**ADDENDUM NO. 4**  
**September 12, 2023**

**ROLANDO RETAINING WALL PROJECT**  
**BID NO. 24-08**

CITY OF LA MESA - ROLANDO PARK BALLPARK RESTORATION

5 FLAG POLE FOOTING

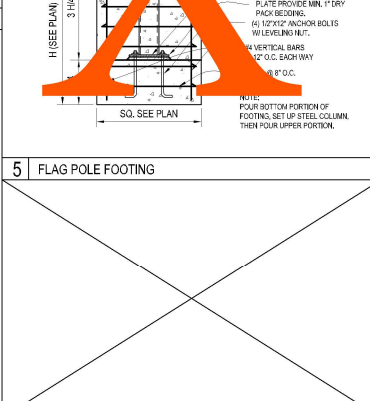
1. Remove Bid Item "Furnish and Install Flag Pole" from the Bid schedule.
2. Remove Specification 201-1.2.1.3 "Furnish and Install Flag Pole" from the Special Provisions.
3. Remove "SD.1 Detail 5" from Project plans and refer all callouts from SD.1 Detail 5 to SD.1 Detail 6 & SD.1 Detail 10 as applicable.
4. Replace Bid Items "Furnish and Install HSS 8x6x1/4" Beam, 14x6x1/4" Beam, Steel Column, and Corrugated Metal Roofing", respectively, and replace with Bid Item, "Furnish and Install Roof Canopy, 304-1.4.5".
5. Remove Specifications 304-1.4.1, 304-1.4.2, 304-1.4.3, and 304-1.4.4 from the Special Provisions.

ALL DETAIL  
REFERENCES TO  
DETAIL 5 SHALL  
INSTEAD REFER TO  
DETAIL 6 (SD.1) OR  
DETAIL 10 AS  
APPLICABLE
